Access Compliance Report

Public Rights-of-Way

(Pedestrian Signals)

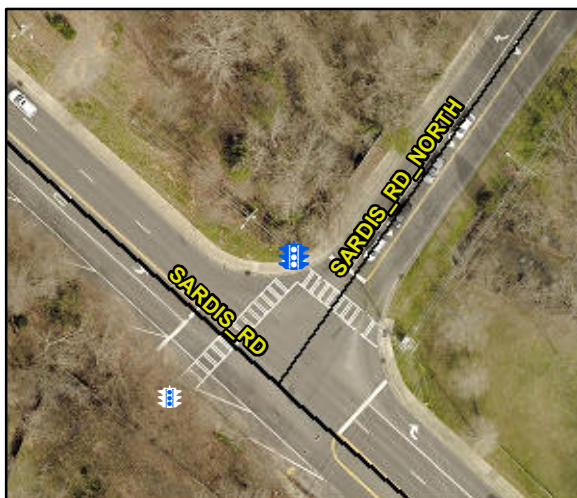
PROW/ADA: R404.2, R406.2

Compliance	Description	Data	Compliance	Description	Data
	Button Count	Button1	N/A	Distant to Additional Button (in)	N/A
	Additional Button Present?	No		Additional Button ID	N/A
N/A	Signal Buttons Required?	N/A	N/A	Additional Ped Posts Required	N/A
	How Many Ped Street Xings?	2		Located In An Island/Median?	No
N/A	B 1 Sign Present?	Yes	N/A	B 2 Sign Present?	N/A
Yes	B 1 Sign Purpose?	Yes	N/A	B 2 Sign Purpose?	N/A
Yes	B 1 Sign Lettering & Contrast?	Yes	N/A	B 2 Sign Lettering & Contrast?	N/A
Yes	B 1 Parallel To XWalk?	Yes	N/A	B 2 Parallel To XWalk?	N/A
Yes	B 1 PAR to Button?	Yes	N/A	B 2 PAR to Button?	N/A
Yes	B 1 PAR to XWalk?	Yes	N/A	B 2 PAR to XWalk?	N/A
Yes	B 1 Clear Floor Space?	Yes	N/A	B 2 Clear Floor Space?	N/A
N/A	B 1 FWD Approach?	Yes	N/A	B 2 FWD Approach?	N/A
N/A	B 1 FWD Approach Constrained?	No	N/A	B 2 FWD Approach Constrained?	N/A
No	B 1 FWD Approach Reach (in)	5.0	N/A	B 2 FWD Approach Reach (in)	N/A

N/A	B 1 FWD Approach Width (in)	N/A	N/A	B 2 FWD Approach Width (in)	N/A
N/A	B 1 FWD Approach Obstruction?	Yes	N/A	B 2 FWD Approach Obstruction?	N/A
N/A	B 1 FWD Approach Obstruction Dist (in)	1.0	N/A	B 2 FWD Approach ObstructionDist (in)	N/A
N/A	B 1 PARA Approach?	Yes	N/A	B 2 PARA Approach?	N/A
N/A	B 1 PARA Approach Constrained?	No	N/A	B 2 PARA Approach Constrained?	N/A
Yes	B 1 PARA Approach Reach (in)	5.0	N/A	B 2 PARA Approach Reach (in)	N/A
N/A	B 1 PARA Approach Width (in)	N/A	N/A	B 2 PARA Approach Width (in)	N/A
N/A	B 1 PARA Approach Obstruction?	Yes	N/A	B 2 PARA Approach Obstruction?	N/A
N/A	B 1 PARA Approach Obstruction Dist (in)	1.0	N/A	B 2 PARA Approach ObstructionDist (in)	N/A
Yes	B 1 Clear Floor Space Slope (%)	0.7	N/A	B 2 Clear Floor Space Slope (%)	N/A
No	B 1 Clear Floor Space XSlope (%)	9.3	N/A	B 2 Clear Floor Space XSlope (%)	N/A
N/A	B 1 PAR Slope (%)	1.6	N/A	B 2 PAR Slope (%)	N/A
Yes	B 1 Height (in)	40.0	N/A	B 2 Height (in)	N/A

Possible Solutions: Provide Push Button Extension. Remove and Replace Clear Space.
